The brands of the BPW Group:

NEWS Aftermarket

AM03 / 2022

Successively conversion of BPW spring U-bolt for ECO Air

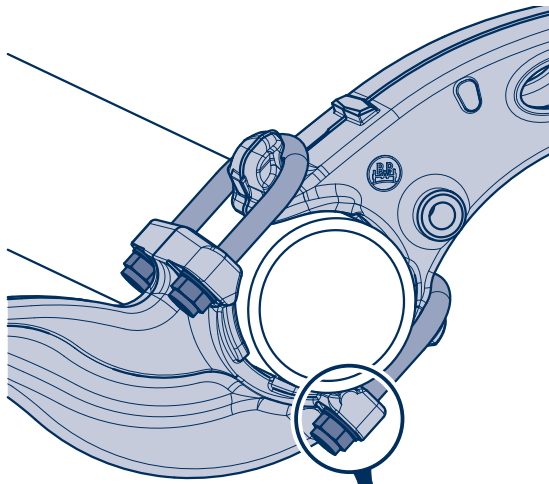
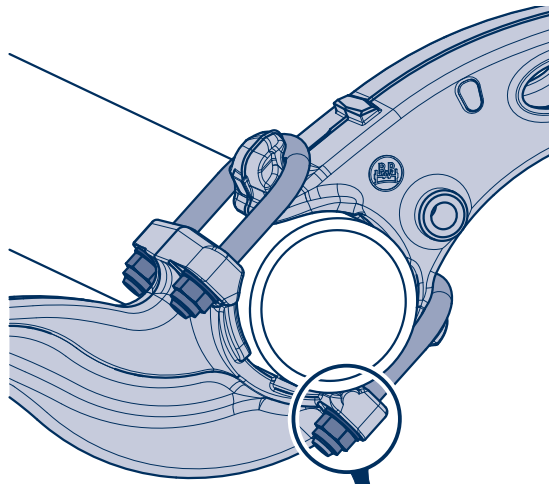
The spring U-bolt will be extended by 5 mm as a result of this conversion. This product enhancement will ensure modularity and enable the BPW air suspension kit to be further expanded in the future.

Please note: The existing version of the spring U-bolt will not be available as an individual part in the aftermarket and is incompatible with the new generation of BPW air bag beams (from Q2/2022)!

Once the old stock will be completely sold out the conversion to the new generation of spring U-bolts will take place – this will be fully backward compatible.

Old BPW item number		New BPW item number	
Spring U-bolt	Repair kit incl. locking nut and washer	Spring U-bolt	Repair kit incl. locking nut and washer
03.138.32.17.0	09.801.09.03.0	03.138.32.18.0	09.801.09.45.0
 New air bag beam Old spring U-bolt		 Old air bag beam New spring U-bolt
